1 Products affected

Product Change Notification					PCN FUL Change of material		
owner	creation date	release date	released by	change order	rev	page	D10-078-707
lutzo	22.09.2023	14.11.2023	schulejo		A	1 of 2

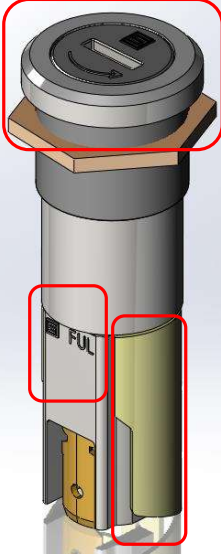
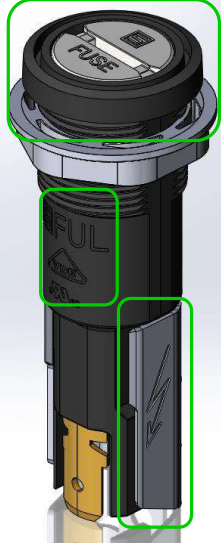
Current plastic material		New plastic material	
Thermoset		Thermoplastic	
Current product appearance		New product appearance	
ISO view	Socket cross-section	ISO view	Socket cross-section
	 1 milled area		 3 milled areas

- New product design
- Position of product marking changed
- New design of cooling plates
- Plastic nut instead of metal nut

- Replace plastic material thermoset with thermoplastic for a more reliable moulding process
- Change to a modern design

The change takes effect in week 11/2024 (Date code 2411 or higher on label).
 Parts on stock will be used upon depletion.

| <input checked="" type="checkbox"/> Form | No action required. Consider new design at incoming inspection. |
| <input checked="" type="checkbox"/> Fit | No action required. The combination of sockets and carriers of current and new materials is permissible. |
